# **Item 10.2: Kenedy Switch-Nixon-Seguin Line Upgrade Regional Planning Group (RPG) Review; ERCOT Independent Review**

**March 19, 2013**

**Date:** March 12, 2013  
**To:** Board of Directors  
**From:** Jeff Billo, Manager, Transmission Planning  
**Subject:** Kenedy Switch-Nixon-Seguin Line Upgrade Regional Planning Group Project

## **ERCOT Independent Review of the Kenedy Switch – Nixon – Seguin Line Upgrade Project**

Figure I: Existing transmission system along the Kenedy Switch – Nixon - Seguin

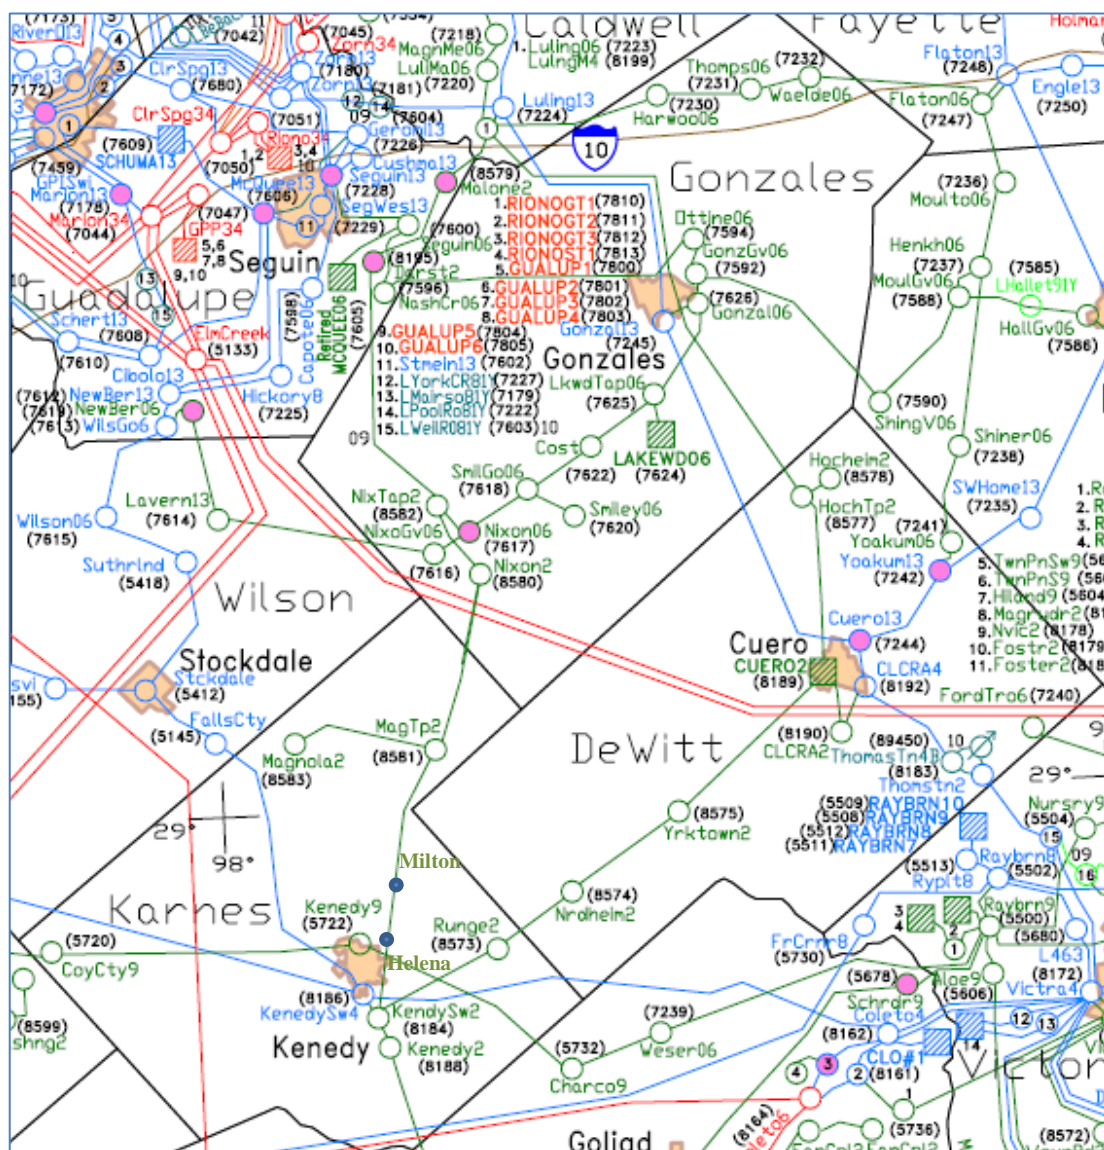
The Milton and Helena Substations were constructed in Karnes County in 2012 to serve a portion of the Eagle Ford Shale related load growth. The transmission service to the Milton and Helena Substations is currently provided by the 35.4-mile, 69 kV, 34.3 MVA Kenedy Switch to Nixon transmission line. The combined initial load forecast for these two stations was 21 MW in 2012. Due to the unprecedented load

growth, the updated load forecasts for the Helena Substation and Milton Substation together in 2015 and 2017 are 46.4 MW and 47.2 MW respectively. As a result, the Kenedy Switch – Helena 69 kV line exceeds its emergency rating under the contingency loss of Nixon – AEP Nixon 69 kV line in 2015 and exceeds its normal rating under pre-contingency conditions in 2017. The Nixon – AEP Nixon – Milton 69 kV line exceeds its emergency rating under the contingency loss of Kenedy Switch – Helena 69 kV line in 2015 and 2017.

Figure III: 2012 Five-Year Transmission Plan overload and contingency

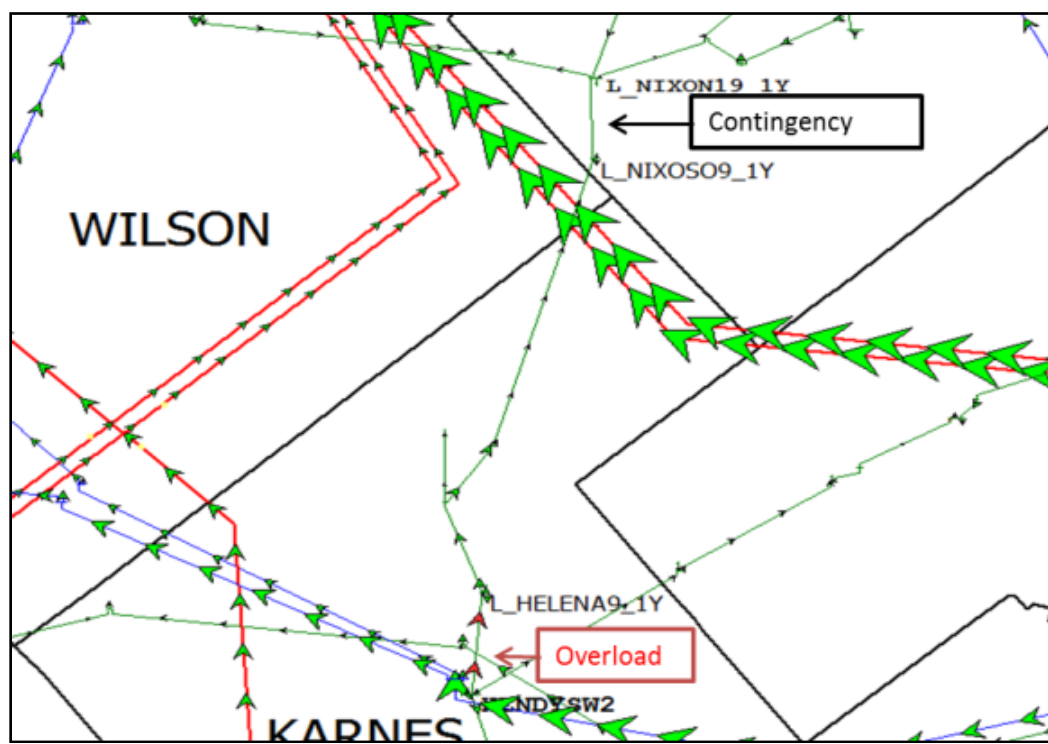
Several 69 kV lines in the Kenedy to Luling area exceed their emergency ratings under several different contingencies. The resulting study overloads and contingencies are shown in Table I and Figure II. To relieve these overloads, the existing 69 kV transmission lines between the Kenedy Switch, Nixon, and Seguin Substations need to be upgraded and converted to 138 kV with 795 ACSR conductor. These upgrades are needed by 2013 since the area has experienced unprecedented load growth due to Eagle Ford Shale oil and gas exploration and production.

Based on the reliability need identified in the 2012 Five-Year Transmission Plan, it was determined that the proposed project would relieve the projected thermal and voltage violations caused by the area load additions mainly associated with Eagle Ford Shale oil and gas exploration and production. Therefore, ERCOT recommend the following transmission system improvements proposed by LCRA TSC, GVEC, AEP and STEC:
